Planning Commission Meeting Minutes

Tuesday, October 26, 2021

PUBLIC HEARING- Santaquin Estates Concept Plan

The Planning Commission will review a concept plan for a proposed 80-lot subdivision (1 commercial lot and 79 single-family lots), located at approximately Main Street and 900 E.

SANTAQUIN ESTATES
C o n c e p t P l a n R e n d e r i n g # 2

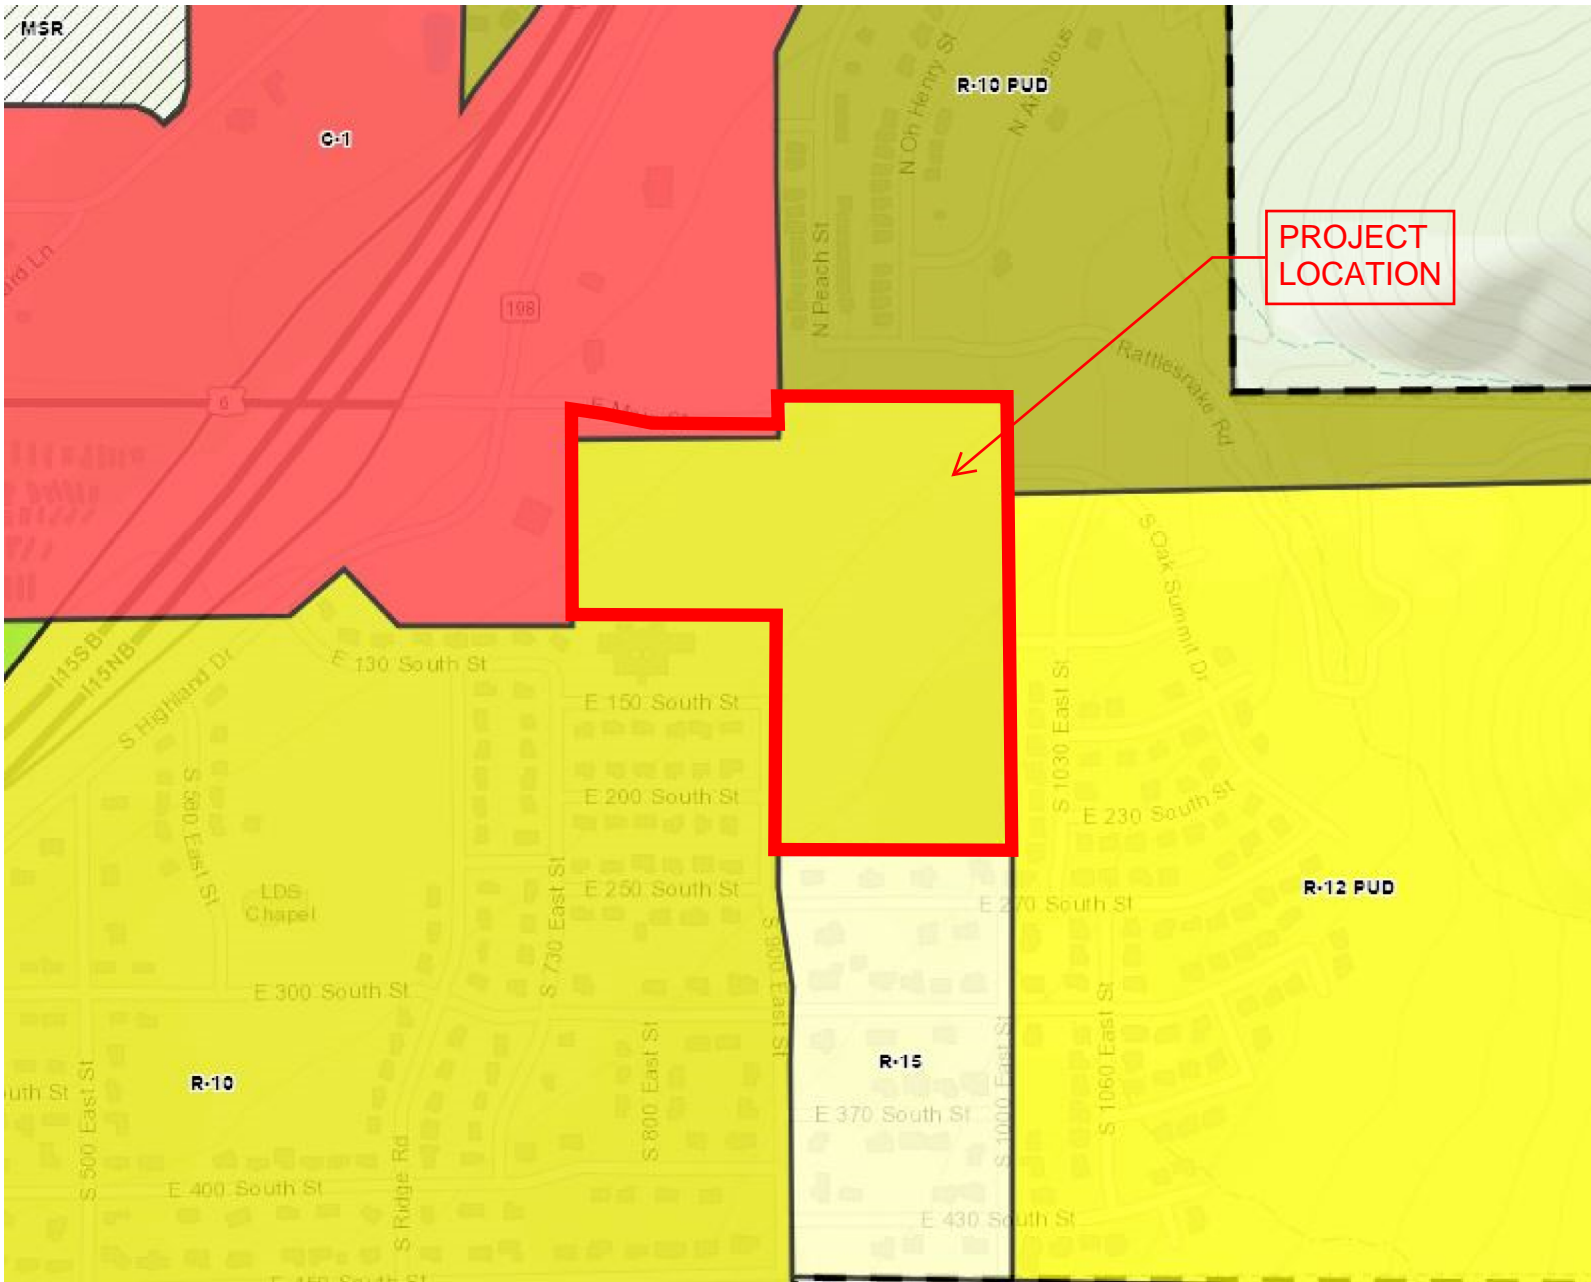
Ms. Melonie Smith shared a statement from Jody Reid who was unable to attend tonight. Ms. Reid expressed concern regarding the lack of open space in the proposal. Particularly the use of the retention basin as a dual-purpose park area. She is concerned that the area won't be landscaped. Ms. Reid doesn't feel that any of the proposed pocket parks are functional for the residents. She also stated that she doesn't think it is appropriate that the commercial parcel is considered in the yield plan. Ms. Reid feels that the proposal of having the higher density homes facing Main Street and is a way for the builder to save money rather than building a fence along the road. She believes having the wall continue along Main Street and 900 E. would help reduce parking issues on Main Street.

Ms. Melonie Smith echoed Jody Reid's concerns. Ms. Smith expressed concern regarding the commercial parcel. She noted that none of the commercial parcel units are identified. She also expressed concern of safety with the proposed realignment of the Frontage Road shifting traffic onto 900 E. sending more traffic into the residential areas.

Mr. Dan Olson expressed concern regarding the slope between 900 E. and the lots that back the south portion of 900 E. He noted that there is no visitor parking provided for the higher density units. Mr. Olson asked to see road dimensions for the proposal to ensure that they meet the requirements. He noted that he loves the commercial aspect of this development. He explained that he doesn't like how high-density housing and commercial are tied together in zoning. Mr. Olson asked that a plan is made with UDOT to ensure their plan for the area, prior to committing to a plan for this development.

Commissioner Jorgensen asked if there are proposed parks with this proposal? Mr. Bond explained that staff is working with the developer to find a creative solution to meet the open space requirements. This could potentially be done through both the retention basin and the developer improving the trail corridor along 900 E. Commissioner Jorgensen pointed out that according to code a maximum of 50% of open space may be utilized for storm drain retention.

Commissioner Jorgensen indicated that she would like to see the detached single family lots increased to 6,000 square feet, and an overall reduction of lots to provide more open space. Commissioner Jorgensen also stated that she would prefer to see the fence continued along Main Street with front loading units. Commissioners Hoffman and Lance disagreed and stated that they prefer the rear loaded units fronting Main Street.

Commissioner Wood asked the applicant to address any of the residents' concerns or discuss their proposal. Mr. Peter Evans with Flagship Homes stated that their plan has evolved over that past year from the public input received. He expressed that he believes this proposal addresses some of the concerns brought up tonight. He stated that the realignment of the intersection will go a long way towards motivating UDOT and moving the process forward. Regarding the houses fronting Main Street he stated that they can consider having them front the interior road if that is preferred. Mr. Evans expressed that they are open to options that would discourage parking on Main Street.
